SUBJECT: Submittal of Workplan for Dongary Investments Site

On behalf of Dongary Investments, Ltd. (Dongary), ERM EnviroClean-West, Inc. (EnviroClean) is pleased to submit the attached Workplan for a site remediation to be performed at the Dongary site located at 2225 7th Street in Oakland, California. This workplan presents:

**REMEDIATION
DONGARY INVESTMENTS, LTD. FACILITY
OAKLAND, CALIFORNIA**

NUTRIENT ENRICHMENT & CAPTURE

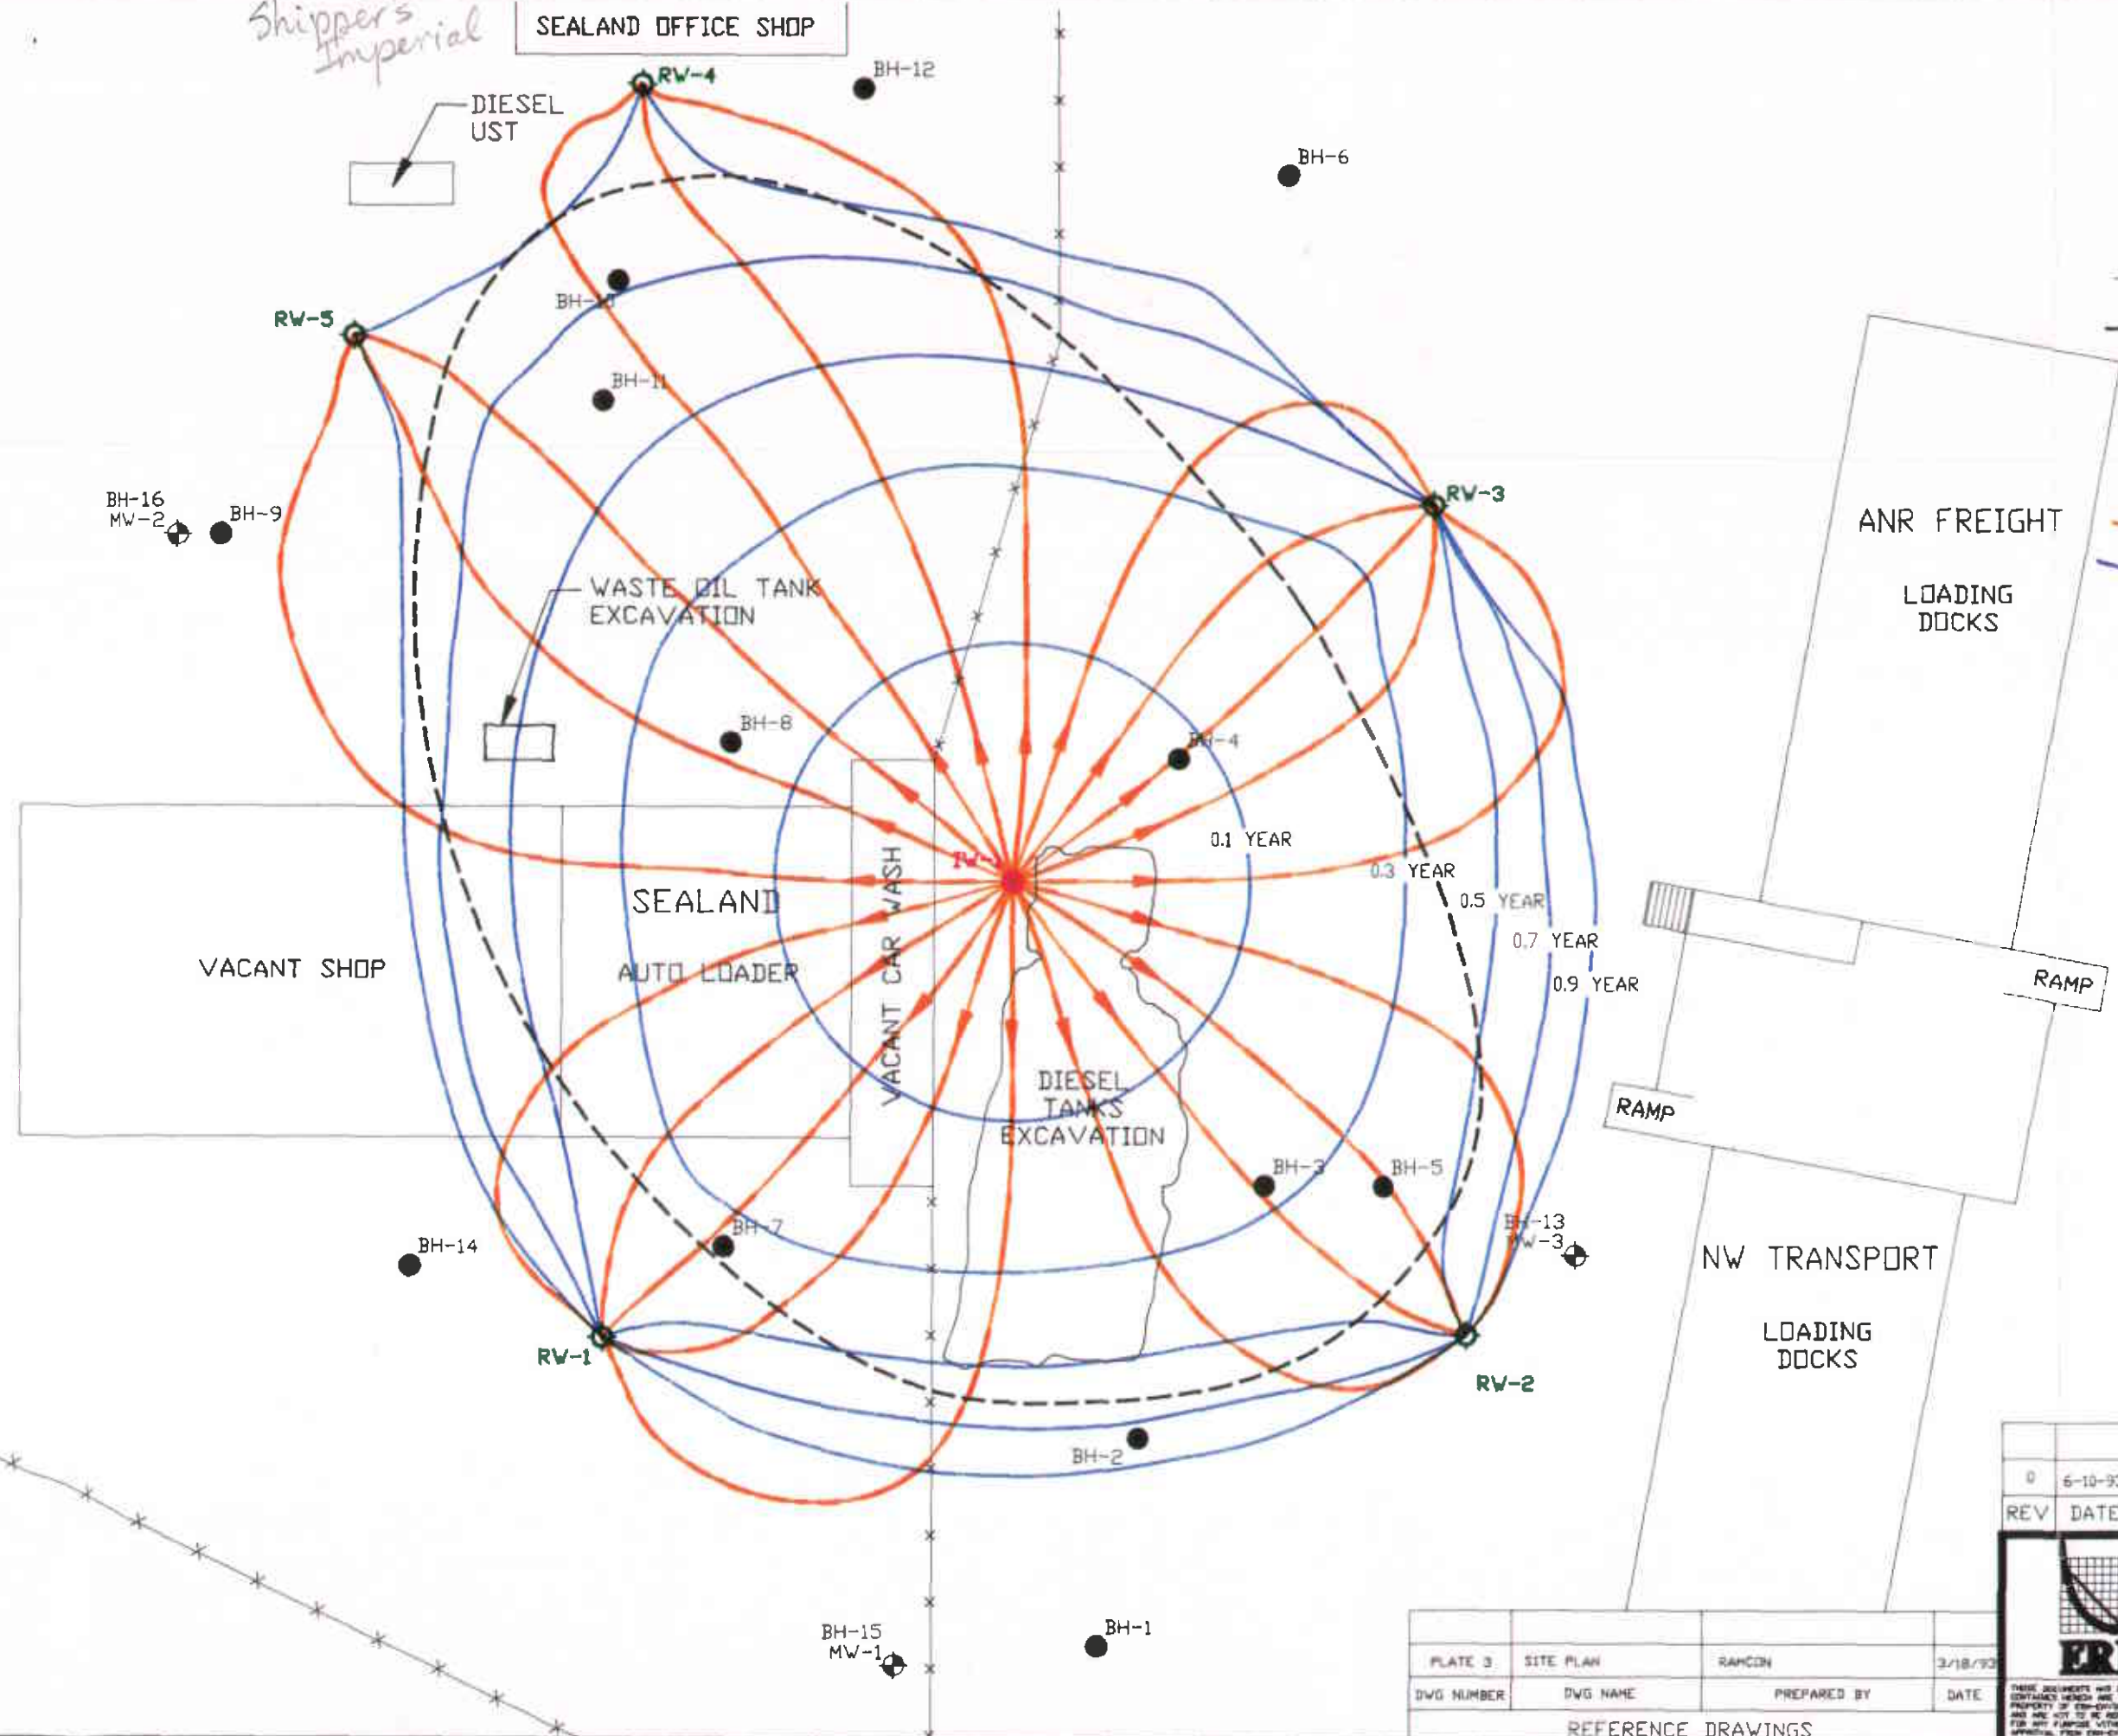
in gw or soil?
